**Dover Municipal Landfill Superfund Site
Second Consent Decree for RD/RA**

APPENDIX A

2004 Amended ROD

RE: Comments to the Amended Proposed Plan, Dover Municipal Landfill

FIGURE 1: Landfill Operation and Contaminant Transport Timeline for Benzene and Vinyl Chloride.

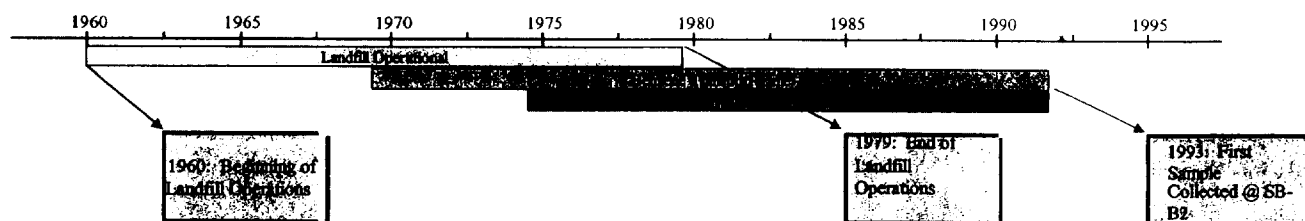
As previously indicated, the Landfill was active from 1960 through 1979. Therefore the maximum time for contaminant migration to the first detection at SB-B2 is approximately 33 years (1960 to 1993). The estimated travel time for benzene from the toe of the Landfill to well SB-B2 (25 years) is less than the maximum possible travel time of 33 years, indicating that the release of benzene to ground water within the Landfill could have occurred as early as 1968. Similarly, the estimated travel time for vinyl chloride from the toe of the Landfill to SB-B2 is 20 years. Therefore, the generation of vinyl chloride by the anaerobic reductive dechlorination of TCE and PCE within the Landfill could have occurred as early as 1973. Based upon these estimates of travel time, simulated VOC migration in the Southern Plume (assuming advective flow and retardation) is reasonably consistent with VOC detections at well SB-B2.

Figure 1 presents a timeline of the operational history of the Landfill and the estimated ranges of travel times for ground water and representative VOCs in the Southern Plume in the vicinity of well SB- B2.
